PLANNING COMMISSION STAFF REPORT RIVERLANDS PLANNED UNIT DEVELOPMENT

FILE NO: PUD19-0002

REQUEST: To develop a 18 lot PUD single-family residential subdivision with associated improvements

LOCATION: 1303 S River Street

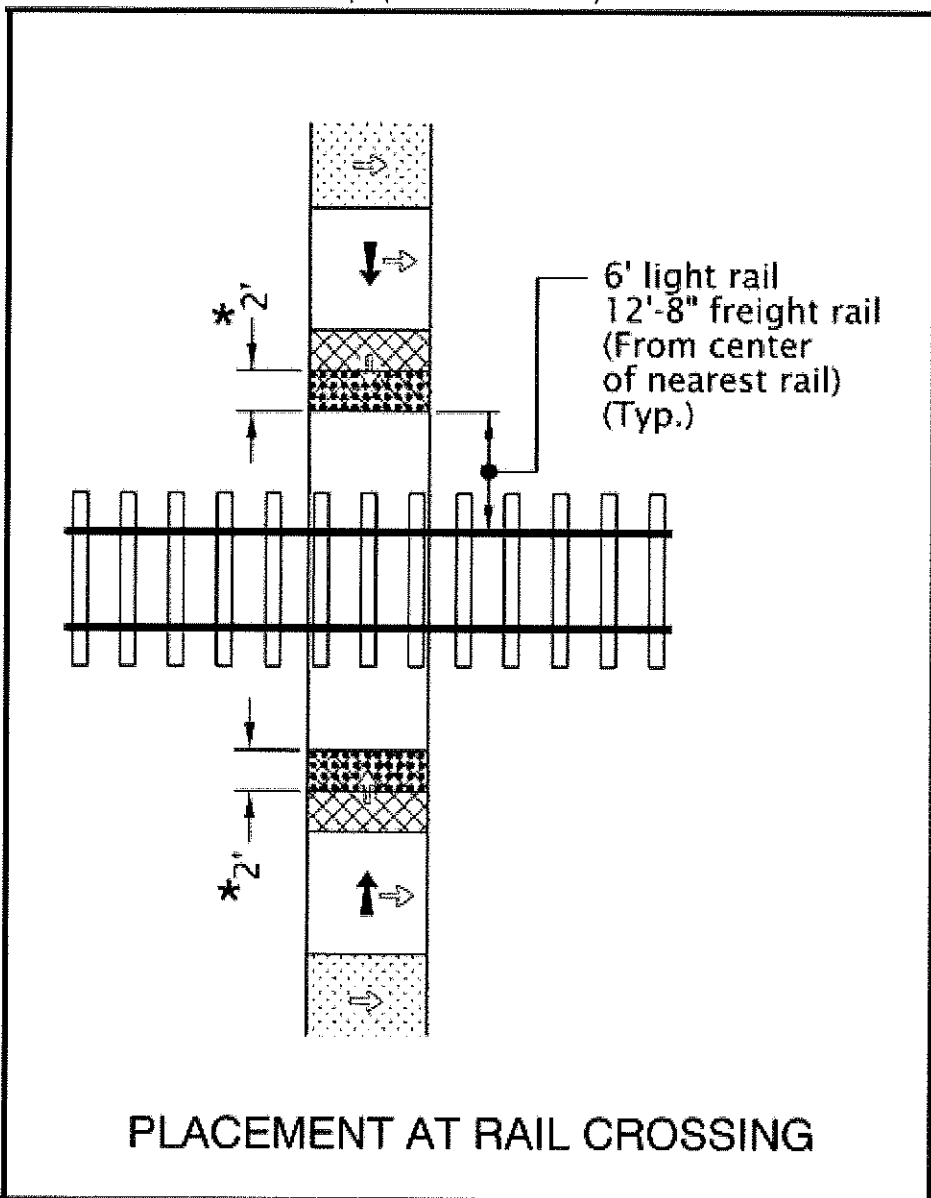
OAR 741-120-0020(2) discusses grade crossing construction and maintenance that the width of the crossing surface (roadway), including sidewalk, approaches to the crossing must follow thru the crossing.

It would also need tactile strips (truncated domes).
